BID # /PROJECT: Bid #22-23-03F Classroom Preparation for ViewSonics – Group 5
SUBJECT: Addendum #1

Portables Sleeving/Power Scope of Work

Buena Vista High School

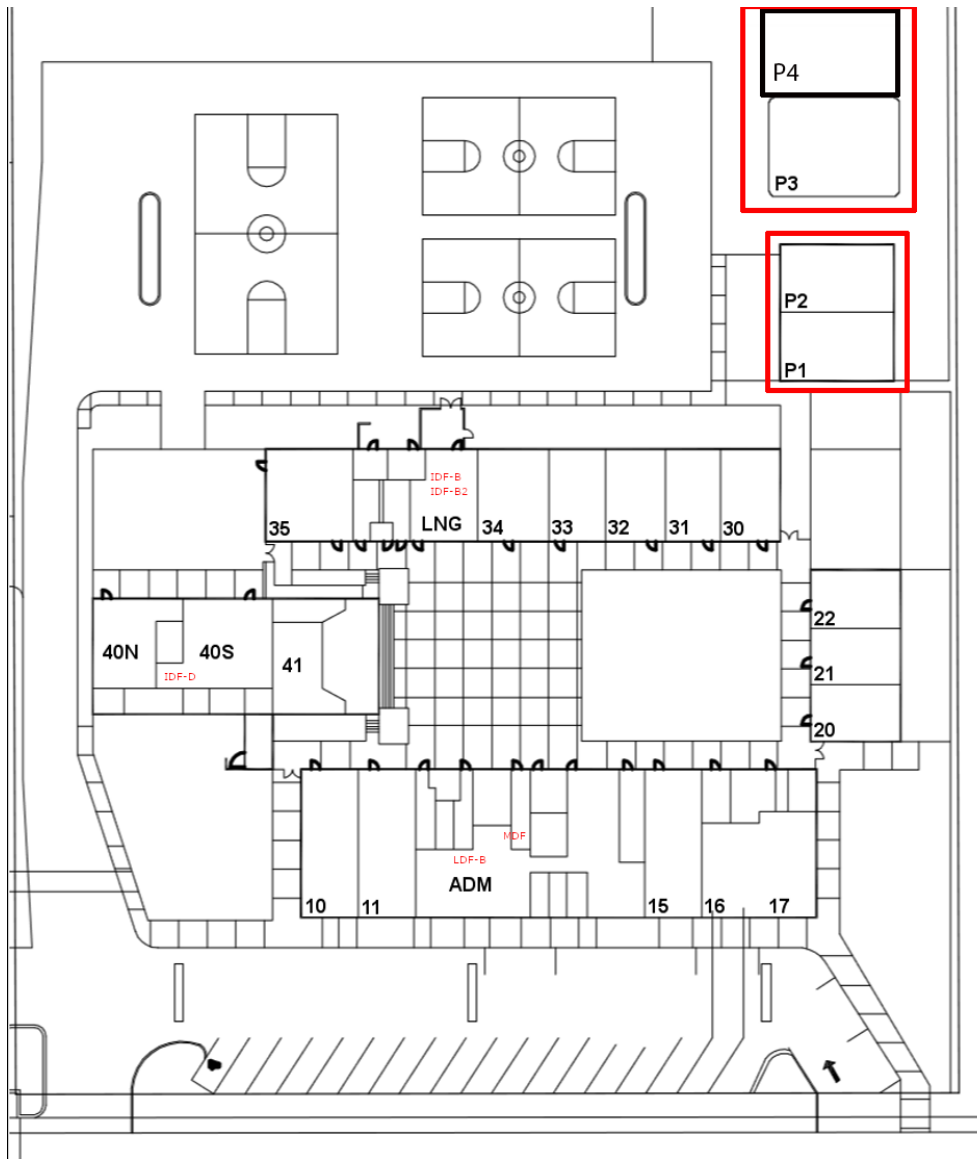
1. Provide and install 2" seal tight conduit pathways between the portable classrooms (1- per portable), Rooms P1-P2, P3-P4
2. Removing and reinstalling the wood protective skirting to gain access.
3. 2" wall penetrations (above ceiling), 2" seal tight, silicone sealant, connectors, supports above the ceiling space, and plastic bushings.
4. The sleeves shall be installed on the side of the portable towards the rear.

Chaparral Elementary School

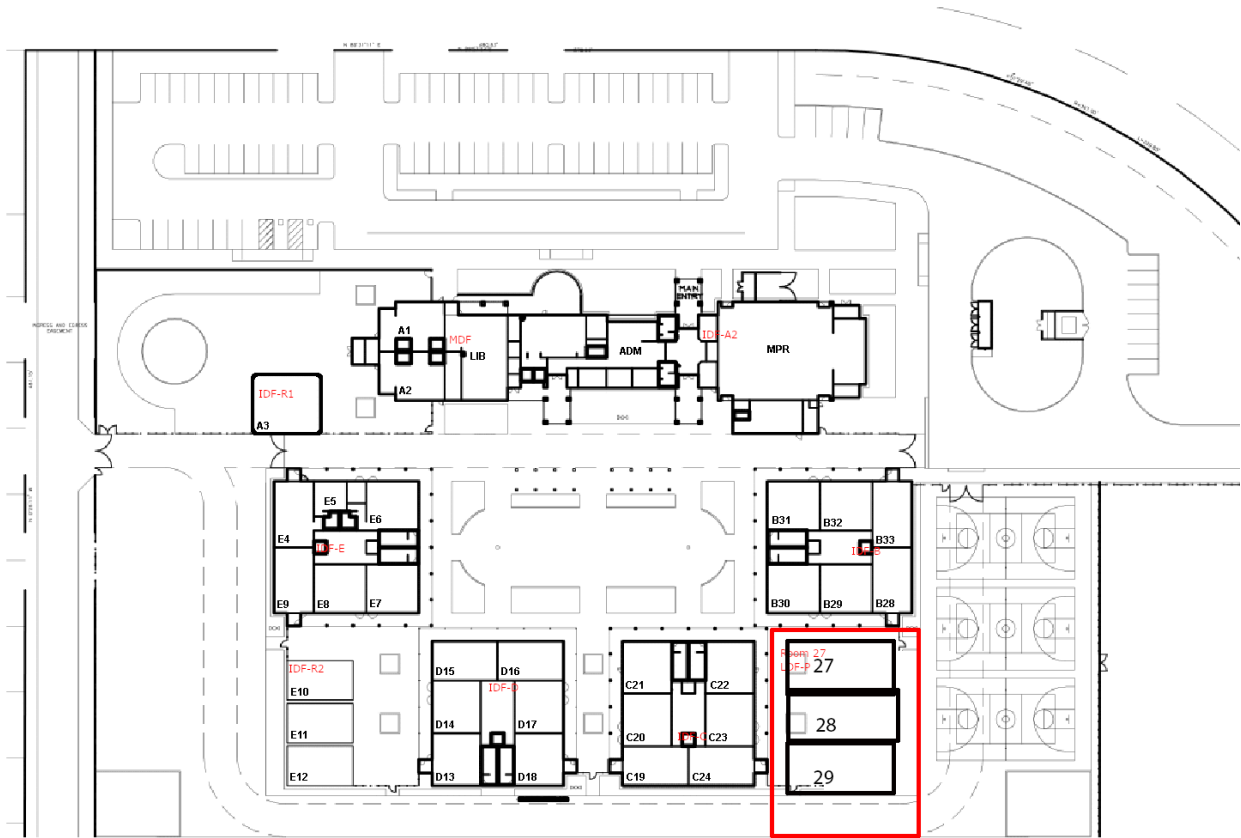
1. Provide and install 2" seal tight conduit pathways between the portable classrooms (1- per portable), rooms 27-28, 28-29
2. Removing and reinstalling the wood protective skirting to gain access.
3. 2" wall penetrations (above ceiling), 2" seal tight, silicone sealant, connectors, supports above the ceiling space, and plastic bushings.
4. The sleeves shall be installed on the side of the portable towards the rear.
